### **STRUCTURES DESIGN BULLETIN 13-01**

### **ROADWAY DESIGN BULLETIN 13-02**

SUBJECT: Median Barrier Mounted Overhead Sign Structures

This bulletin revises and expands on the Department's policy for attachment of overhead sign structures to concrete median barrier walls and revises *Design Standards* Index 410.

OPTION 1

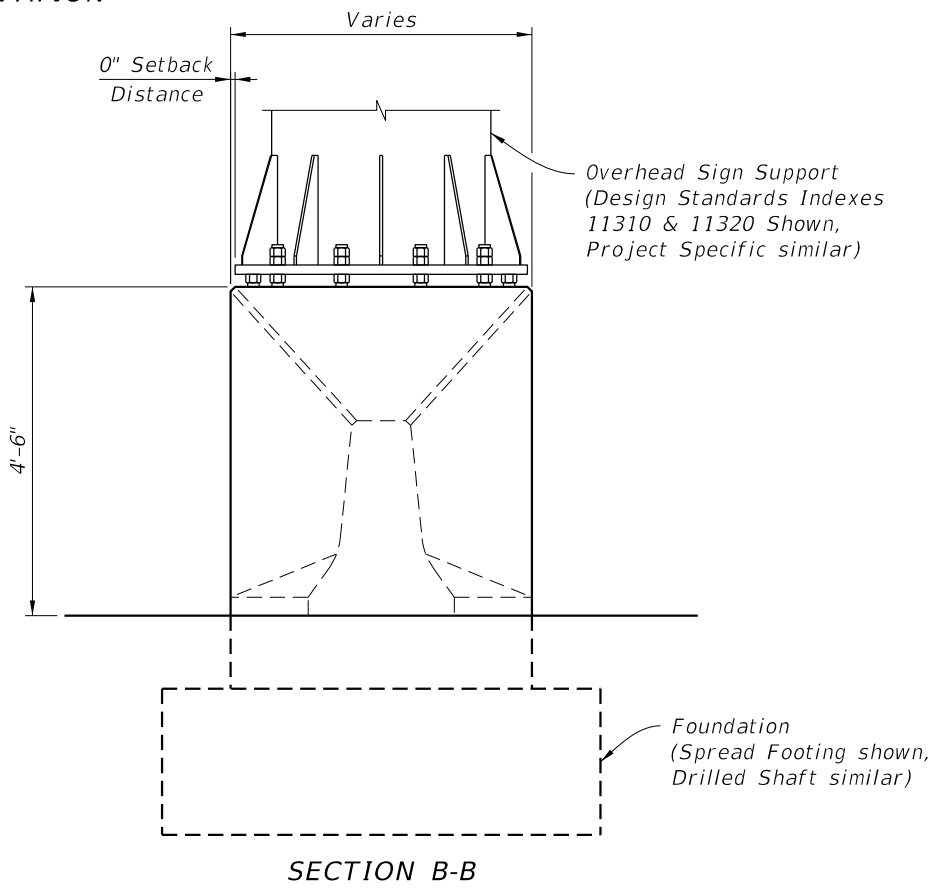
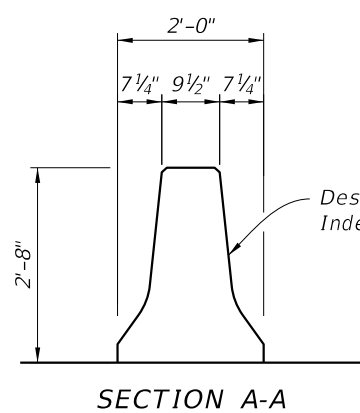
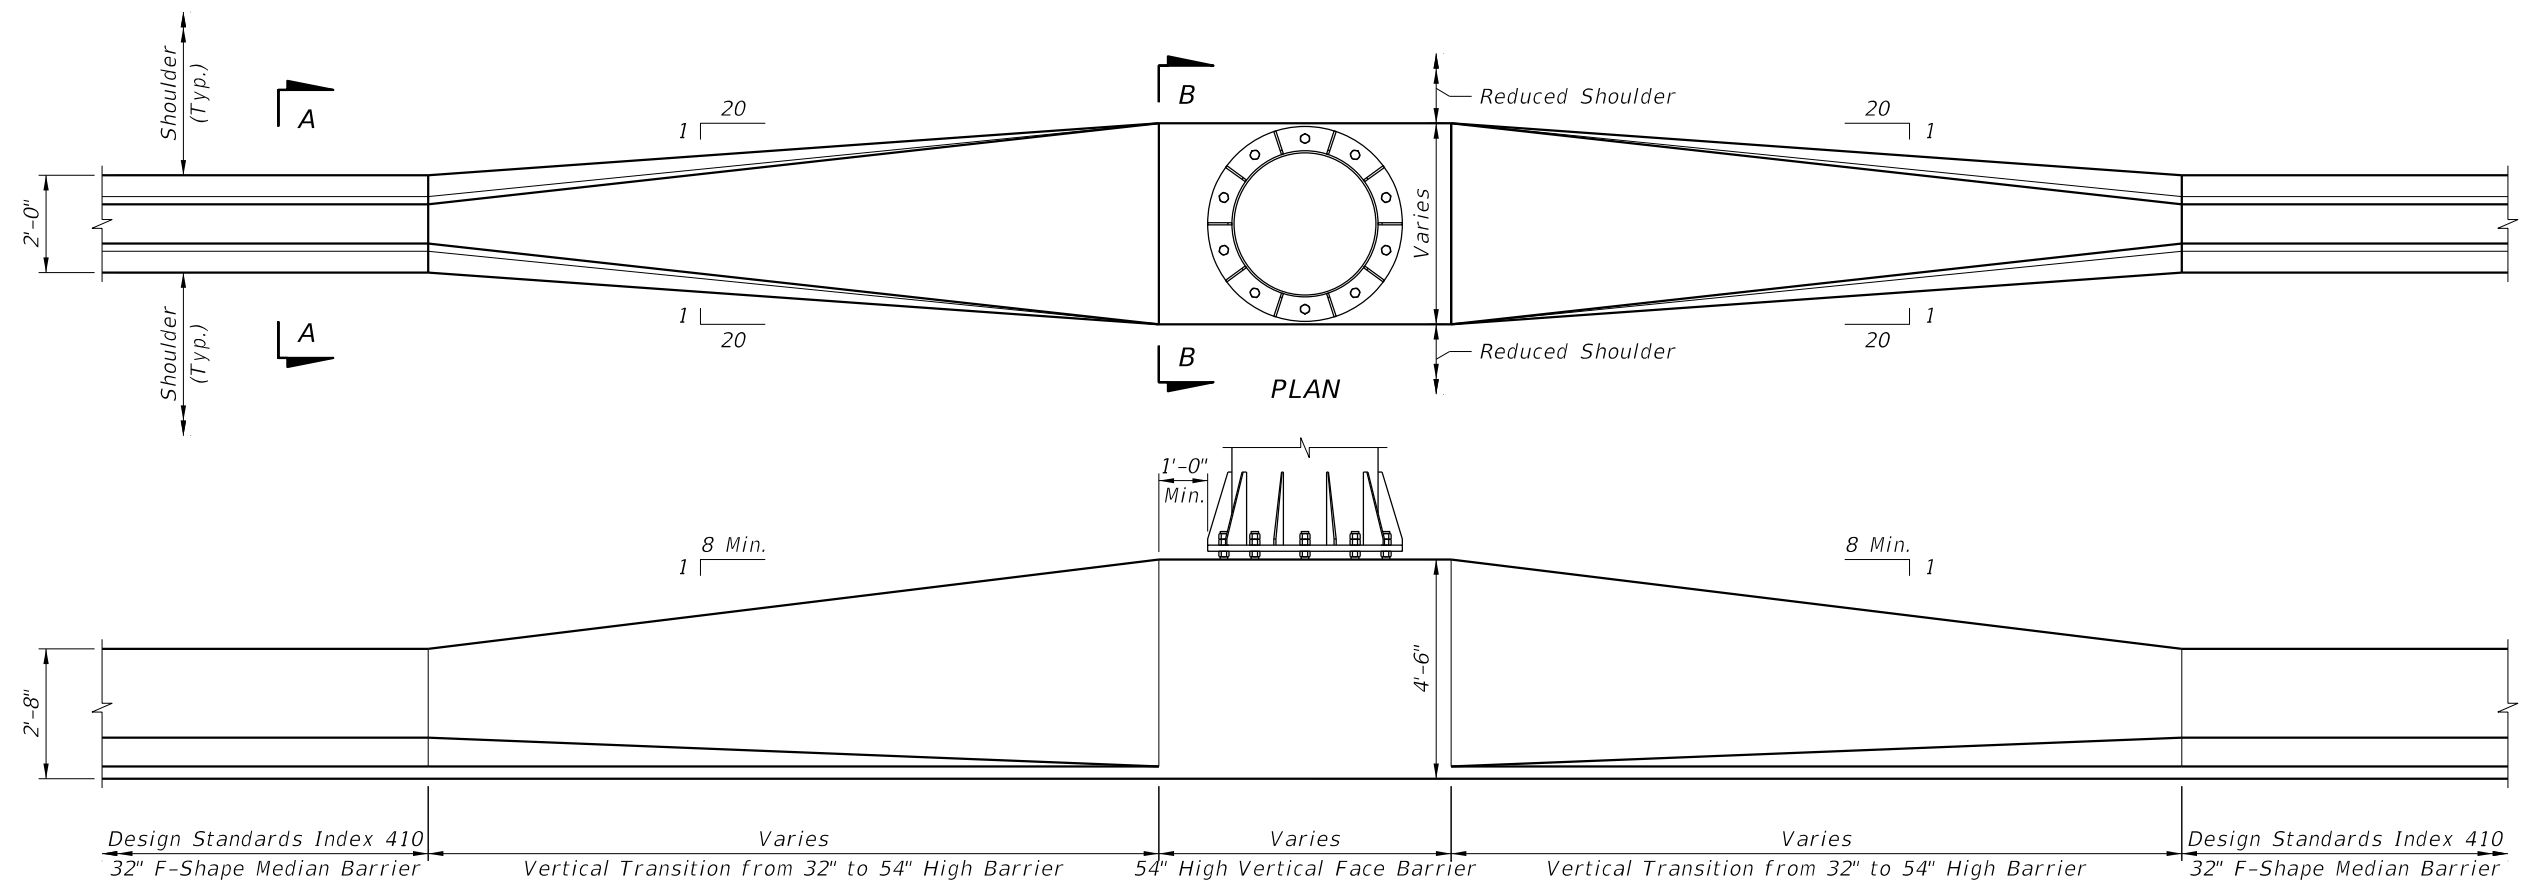
In Option 1, the height of the median barrier wall is transitioned from 32" to 54" and the shape is transitioned from the standard F-shape to a vertical face over a length of 15'-0". The base plate and anchor bolts of the sign support upright are located at the top of the 54" tall section of vertical face median barrier wall. A setback distance of 0" to the base plate is utilized on both sides of the 54" tall median barrier wall which is consistent with that shown for Index 425 in *PPM* Volume 1, Figure 7.1.2.1. The median barrier wall and the top of the 54" tall vertical face section are a constant 2'-0" width which limits the maximum base plate diameter to 2'-0". This in turn limits the maximum diameter of the sign support upright. Anchor bolt and reinforcing steel placement within this section of wall may further limit the maximum diameter of the upright. Project specific details for the median barrier wall and sign support foundation are required and must be included in the Plans. *Design Standards* Indexes 11310 or 11320, or a project specific multiple upright sign support structure may be used. Details must be included in the plans for project specific multiple upright sign support structures. Consider the need for vandal protection guards when using multiple upright sign support structures. This option does not reduce the width of the inside shoulders.

OPTION 2

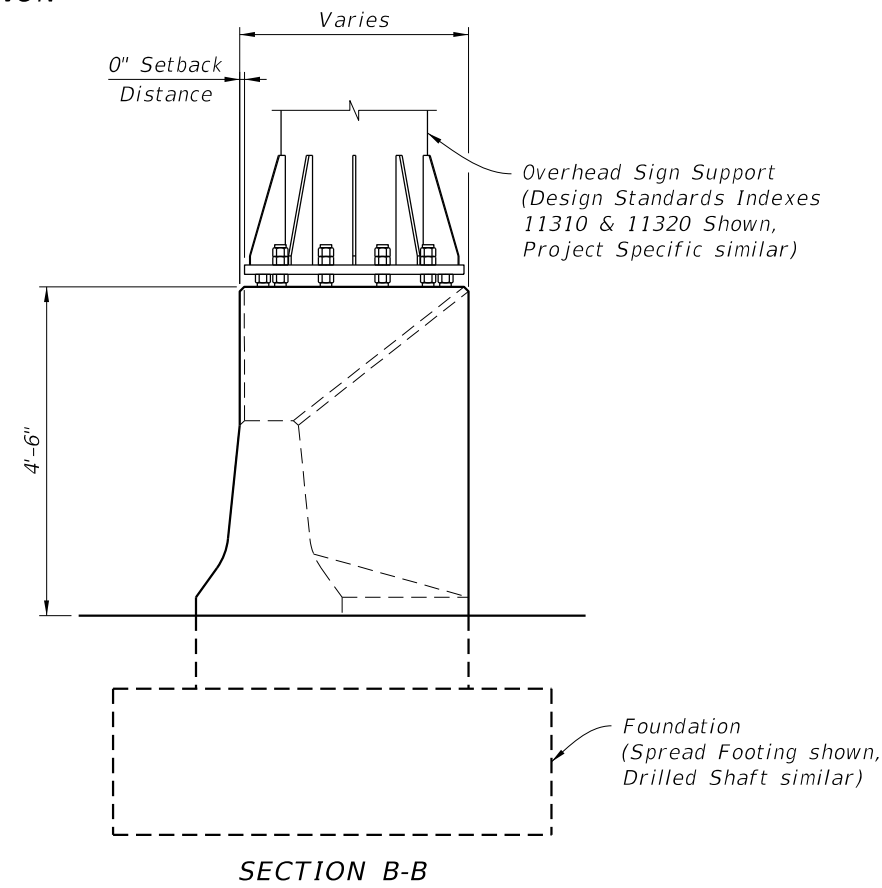
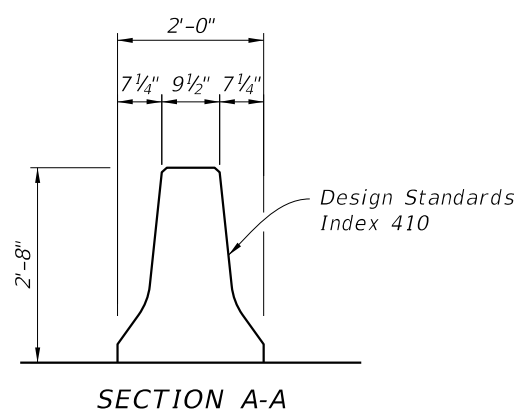
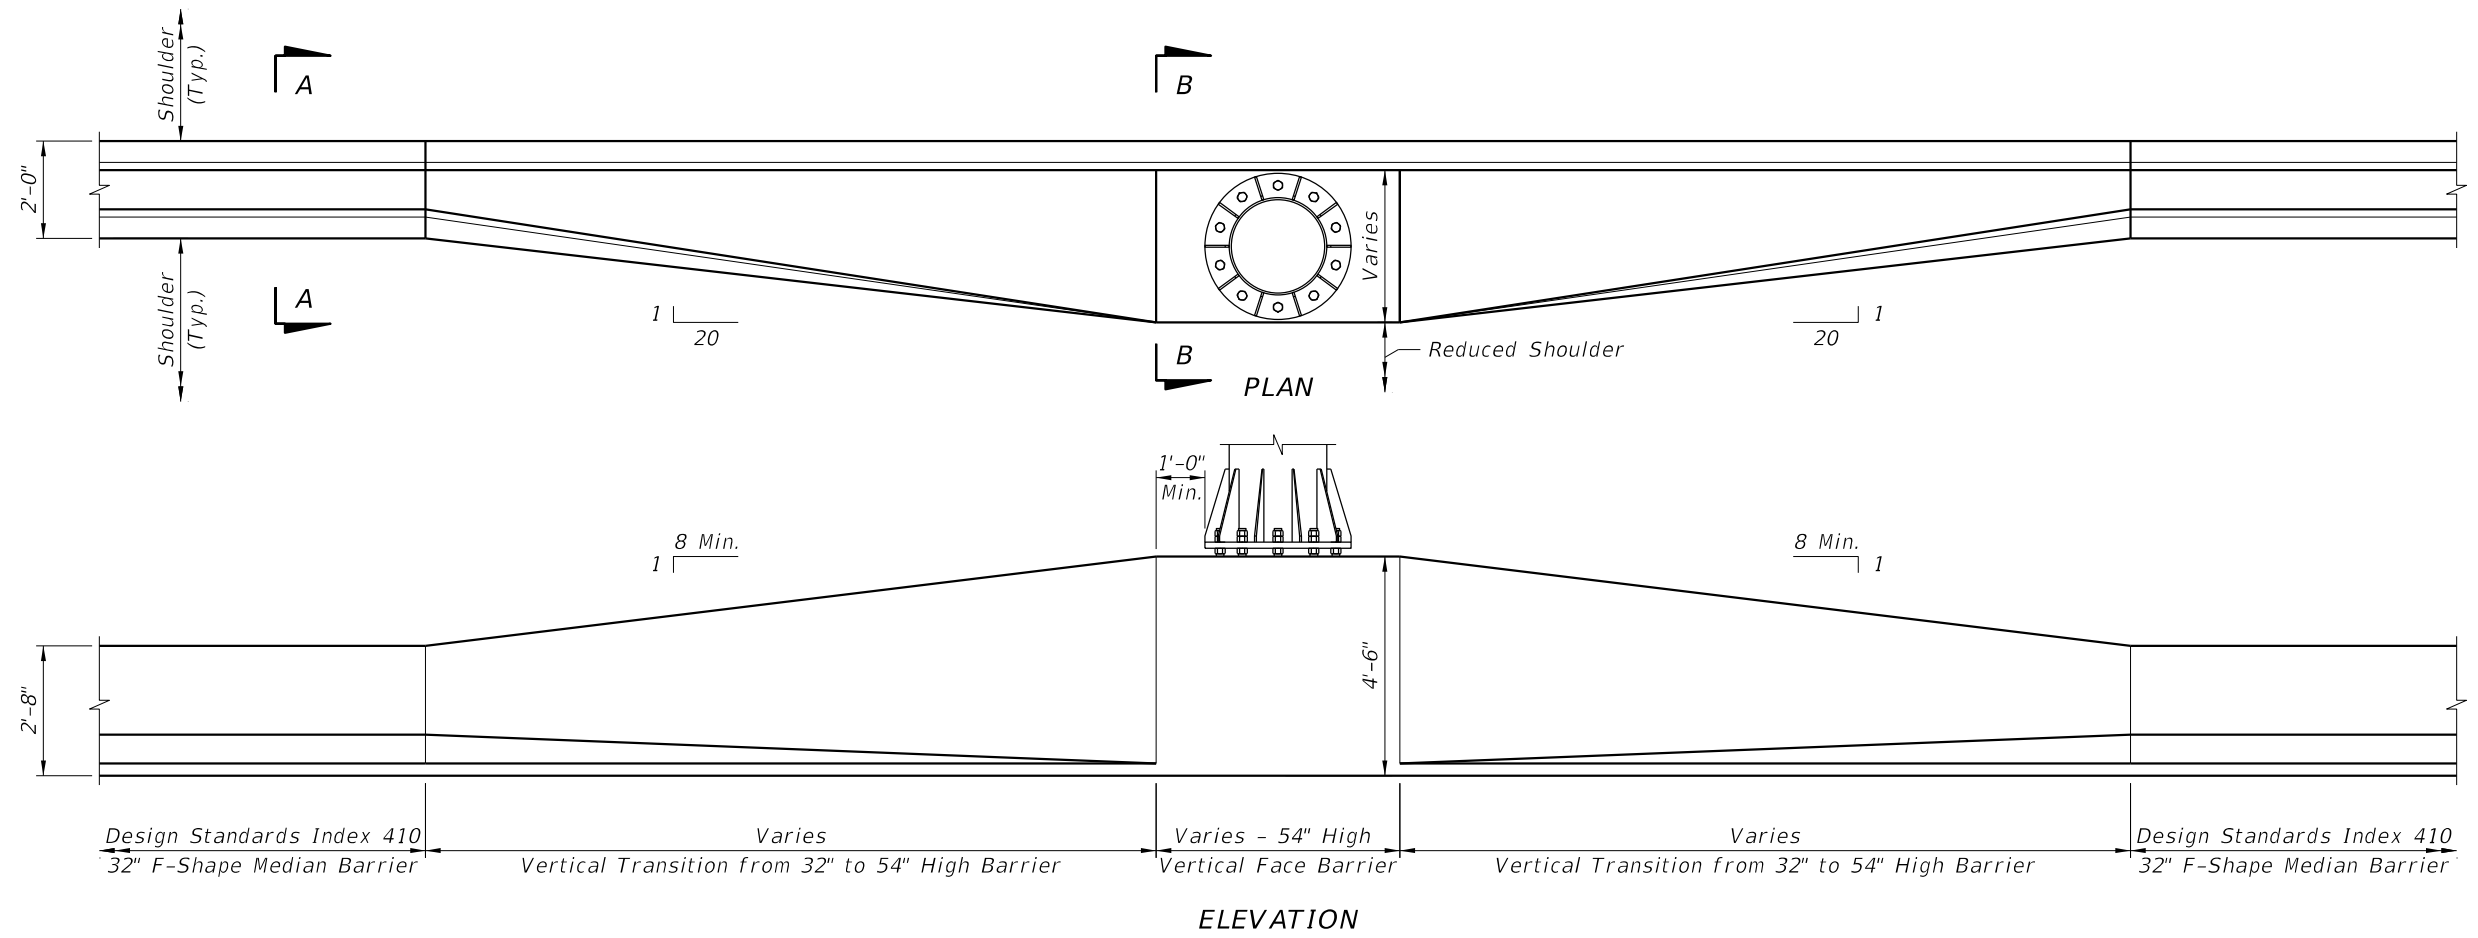
Option 2 is similar to Option 1 except that the median barrier wall is flared out to accommodate larger diameter sign support uprights and base plates. This option reduces the width of the inside shoulders on both sides of the median barrier wall. A Design Exception for shoulder width may be required.
